Subject: [EXTERNAL] Ballarat North PSP - Powercor

Ballarat North PSP

Core and expanded precinct areas

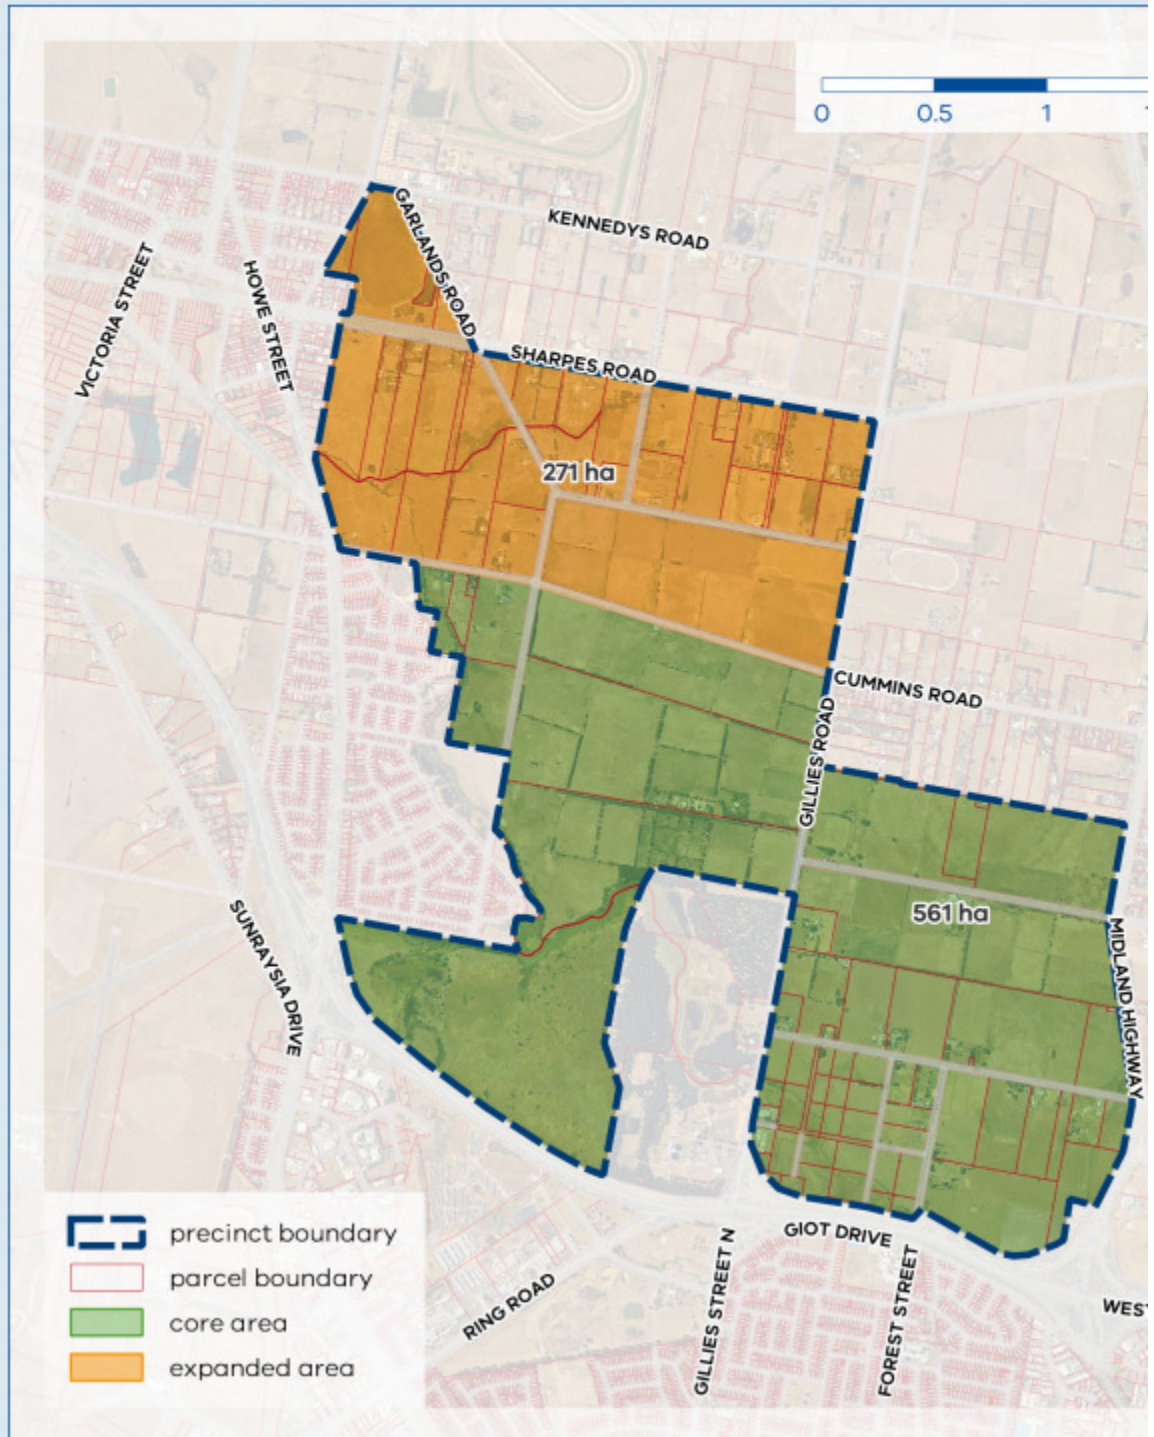
- **Core area demand:** ~33 MVA based on 6,700 dwellings (ADMD method).
- **Substation location:** A new ZSS could be sited near the existing 66 kV line to leverage viable supply routes and proximity to major loads.
- **Kiosk substation reserves:** Standard size 7.2m × 7.2m should be factored into land allocation.
- **Network layout:** Existing 66 kV line (refer attached map) could support a future ZSS.

Existing 66kV Line: There is an existing 66kV line (shown in red in the attached map) that could be used to supply a new zone substation. This should be factored into the planning for future infrastructure.
